SERVICE ALERT

NO.: 1420 Rev A

DATE: April 29, 2014

SUBJECT: Standby Navigation Database

Figure 1

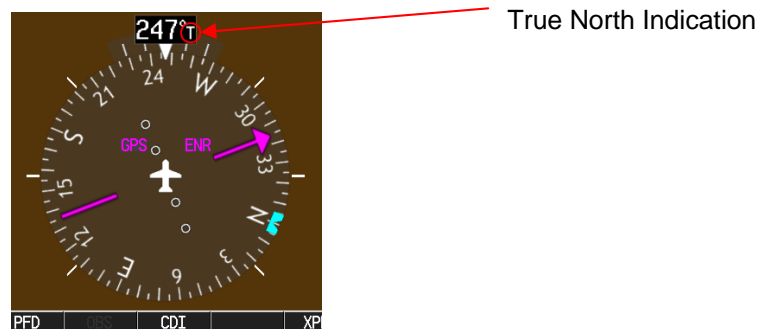
Until system power is cycled again (after the standby to active database transfer), navigation information may be absent and the HSI (Horizontal Situation Indicator) displays a “T” (normally indicates True North) following the HSI digital heading readout (refer to Figure 1) when True North is not selected.

This condition is corrected by cycling system power after the standby navigation database is transferred to the active navigation database, as indicated by the system message “NAV DB UPDATED – Active navigation database updated.”
